CONSIDERATIONS FOR REARVIEW  
MIRROR SYSTEMS FOR  
LARGE TRUCKS

Docket No. 71-3a; Notice 4  
Department of Transportation  
National Highway Traffic Safety Association

By:  
Paul L. Olson & David V. Post  
Highway Safety Research Institute  
The University of Michigan  
Ann Arbor, Michigan 48109

April 1979

Figure 1. Bus, truck & MPV side & rearward visibility targets. (Taken from Federal Register, Vol. 43, No. 215, Monday, November 6, 1978, page 51675.)

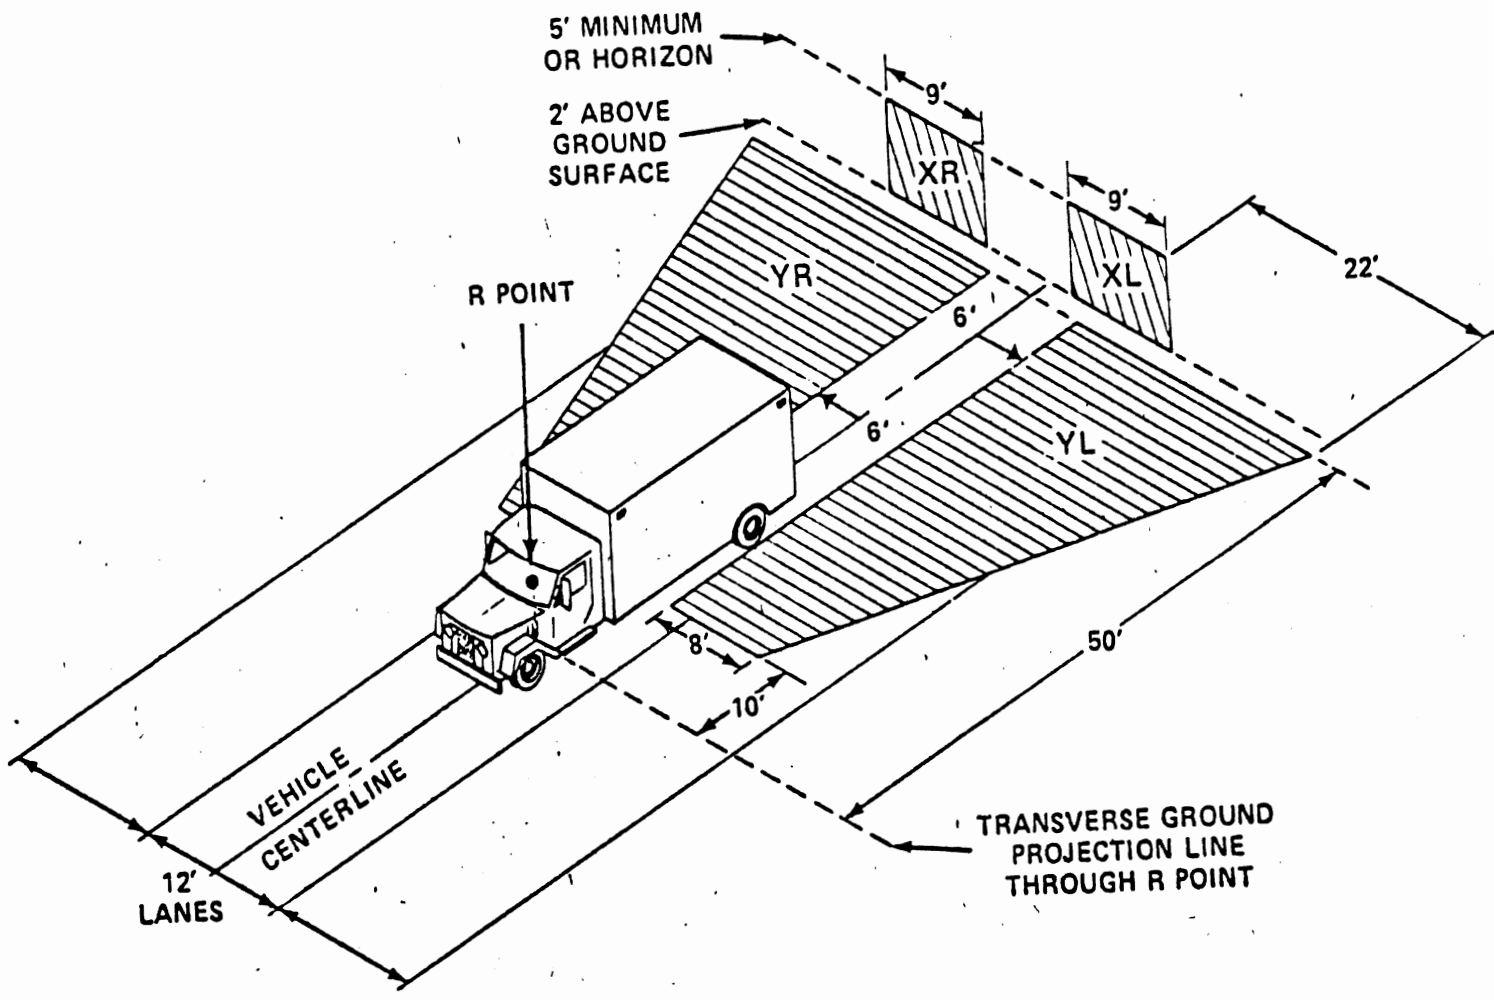
We are concerned that the proposed rule may not address this issue adequately. By only specifying a ten foot distance back of the "R" point for the front boundary of the trapezoidally shaped ground areas YR and YL, the rule allows potentially large blind spots to exist.

Figure 2. Illustration of the blind spot associated with a particular cab-over tractor assuming conformance to the proposed rulemaking. No object under the heavy black lines in the adjacent lane could be seen by a tall driver.

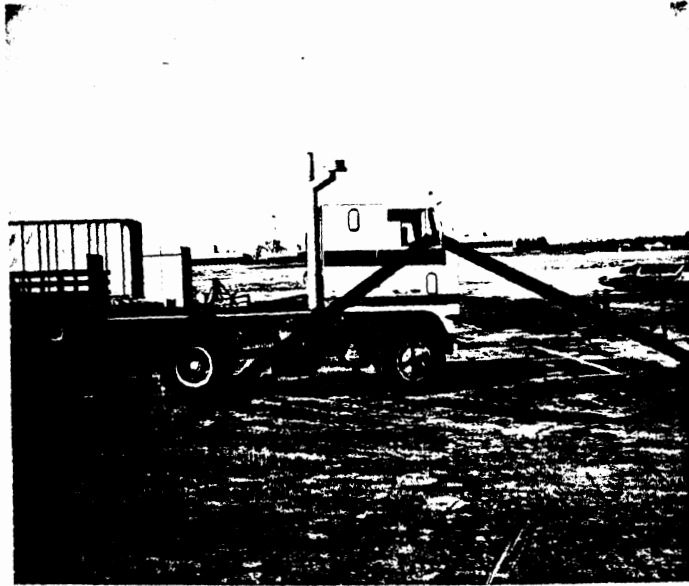
Figure 2 is a photograph of a medium size cab-over tractor. The lower edge of the window (and mirror) on the passenger side is 6' 11" above the ground. For this case the blind spot (assuming adherence to the proposed rules) is approximately defined by the area under the two black lines. This area is large enough to hide a substantial vehicle.

Figure 3 illustrates the problem more specifically. Positioned as shown, the rear roof structure on this large station wagon would have been visible in a mirror adjusted according to the proposed rule. In the brief tests carried out by the authors, a tall (95th percentile seated height) driver could see the end of the hood as well. However, a shorter driver (about 50th percentile seated height) could not see the hood. In any event, at best, only small portions of the vehicle could be seen, in corners of the mirror or windshield. The likelihood that they would be missed by a busy driver glancing in the mirrors is high. It should also be noted that the same make of vehicle, in a sedan model, would have been totally hidden to the shorter driver.

The authors feel that there are practical means for greatly reducing the blind spot on the passenger side of trucks. Thus it should be possible for the government to rewrite the specifications to insure that no car-sized object in an adjacent lane could be outside the driver's field of view.

Figure 4. The smaller station wagon shown is completely contained within the blind spot associated with this tractor.

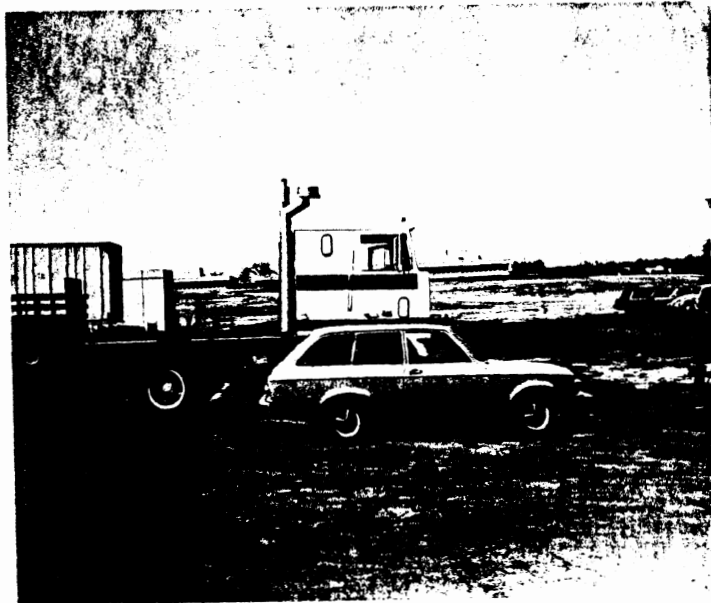
The small station wagon shown in Figure 4 fits the blind spot with about a meter to spare. It would be totally hidden from view even for the tall driver.
